Appendix B – Comments on any further information received by the previous deadline (Deadline 7)

A12 Chelmsford to A120 Widening Scheme

The proposed Blue Mills LWS boundary 2022:

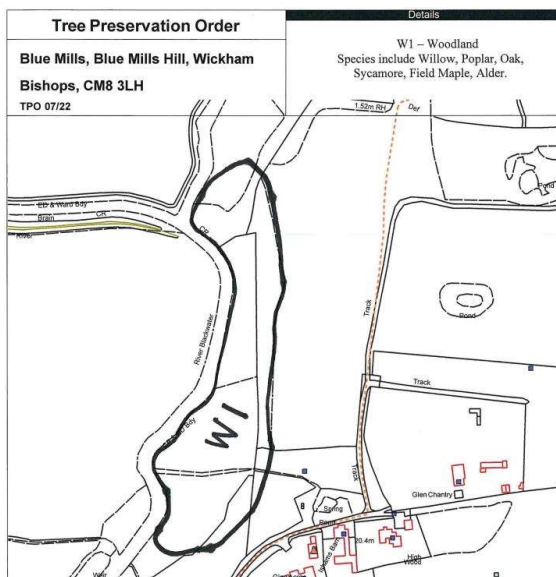
2.8 Section 7 Environmental Matters, subsection 7.6 Biodiversity, paragraph 7.6.47 of the Applicant's Closing Statement **[REP7-078]** refers to "*however it is still possible a corridor of up to 30m would be cleared through the part of the proposed LWS which does not overlap the TPO.*" Paragraph 7.6.49 also refers to a "*ride which would be created*". It is MDC's position that the section of the proposed LWS that is within the Order Limits, is also covered by TPO 07/22 in its entirety, with the exception of the riparian edges of the River Blackwater and therefore this statement is not achievable by the Applicant or Project. There are however parts of the woodland covered by TPO

07/22 which are not covered by the proposed LWS, but which are otherwise within the Order Limits. The boundaries for both are provided in the MDC Local Impact Report **[REP2-068]** and can be provided electronically to the ExA or Applicant to assist in understanding this area.
